Ford Energy from Waste Limited

Ford Energy Recovery Facility - EPR/MP3904BD/A001

Schedule 5 Response No 1

Figure 1: Excerpt from site section drawing

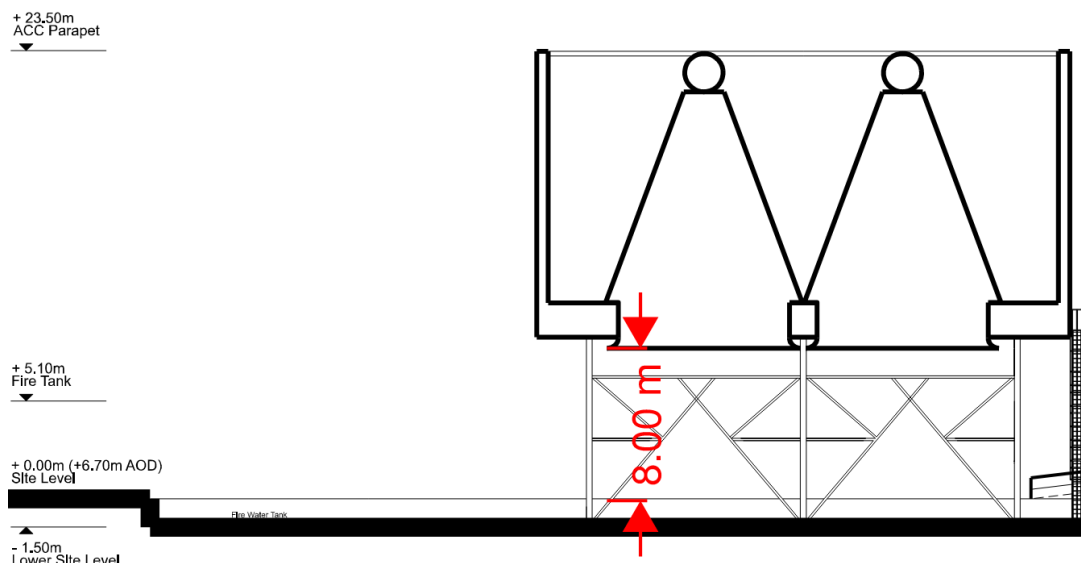
e. Provide further explanation of how the ACCs have been modelled and how they are configured in relation to the screen.

The site section drawings (Refer to the except in Figure 1, with the full drawing presented in Appendix C) show the bottom of the Air Cooled Condensers (ACCs) at 8.0m above the 0.0m ground level. An area source has been input to the noise prediction model at an absolute height of 8m above ground level as shown in Figure 1.

A screen was input to the model, as per the site section drawings. The bottom of the screen is modelled at a height of 8.50m above 0.00m ground level, and the top of the screen is modelled at 23.50m above the 0.00m ground level, refer to Figure 1.

The ACCs are elevated to allow sufficient air flow to the bottom of the ACCs. As the ACCs will draw in air flow from the bottom of the ACCs, the bottom of the ACCs is considered to be the key noise source.

Therefore, the area source was input to the model at the bottom of the ACCs (8.00m above the 0.00m Site Level), just below the proposed screen (8.50m above the 0.00m ground level). This approach allows the noise emissions from the ACCs to propagate around the bottom of the ACC screen; therefore, this does not over predict the noise attenuation that will be provided by the proposed screen. Modelling the ACCs in the middle of the proposed screen could underestimate the resultant noise levels at the nearest receptors.
